SB-A500A-3210-01	Revision:	--
		Type:	EA 400
Model:		EA 400-500	
Project:		A500A-16-03	
Date:		15. Jul. 2016	
Design Organisation EASA.21J.551

SERVICE BULLETIN

MLG SHOCK ABSORBER UPDATE

Figure 6.2 New Fluid Pressure Placard and Serial Number Placard on the LH shock absorber

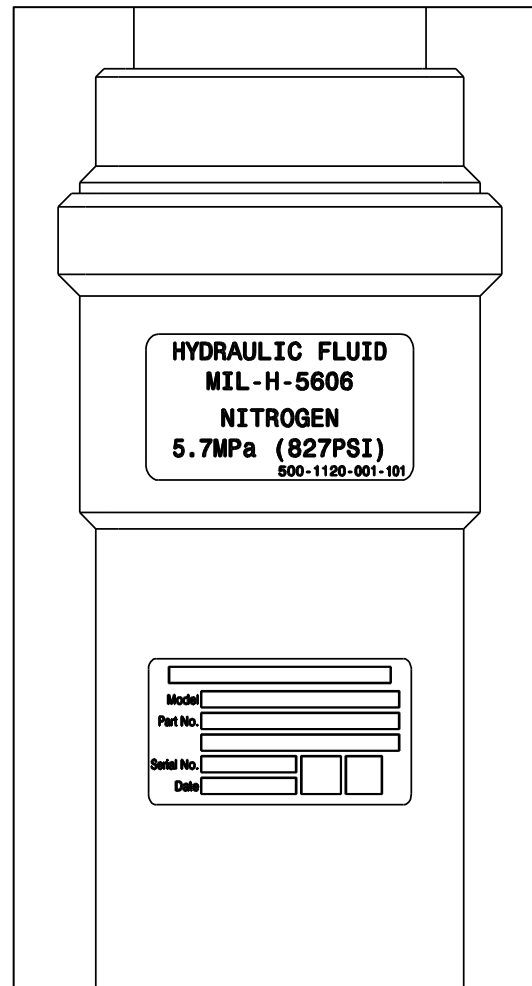
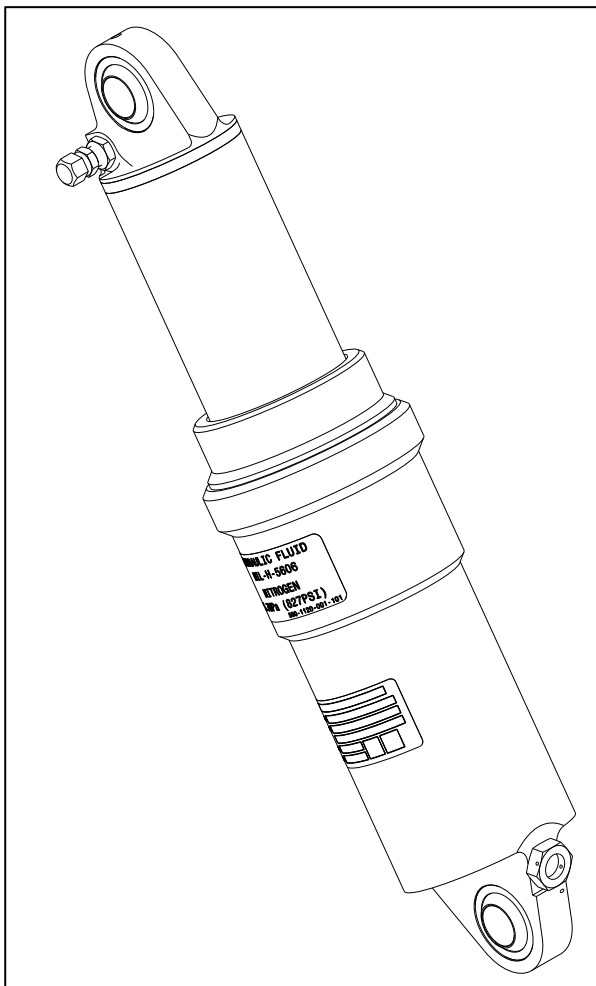
This Service Bulletin is issued to correct two Placards on the shock absorbers of the main landing gear. In addition, compliance with this Service Bulletin will correct and detail maintenance instructions for the installation of the shock absorbers. Disregarding of this Service Bulletin may lead to false shock absorber installation which can result in failure during retraction of the main landing gear.

Remove existing Serial Number Placard and Fluid Pressure Placard (refer to Figure 6.1) from both shock absorbers of the main landing gear.

- Clean and degrease surfaces thoroughly with suitable cleaning solvent.
- Apply new Serial Number Placard and Fluid Pressure Placard (refer to chapter 7 for Part Numbers) in accordance to Figure 6.2.
 - Note that the left and right shock absorbers are not identical but mirrored. Thus, the Part Numbers **must** be taken into account for the replacement of the Serial Number Placards as follows:

- In case of any doubts the side of installation can be identified by the following fact. The nitrogen valve points forward (into flight direction) and is located at the lower inboard position referring to the upper bearing as depicted in Figure 6.2 exemplarily for the left hand shock absorber.
- Cover both placards with transparent foils (POS 3).

Present Part Number	New Part Number	Location on Aircraft
40055131 B	500-3213-008-001	LH side
40055231 B	500-3213-008-002	RH side
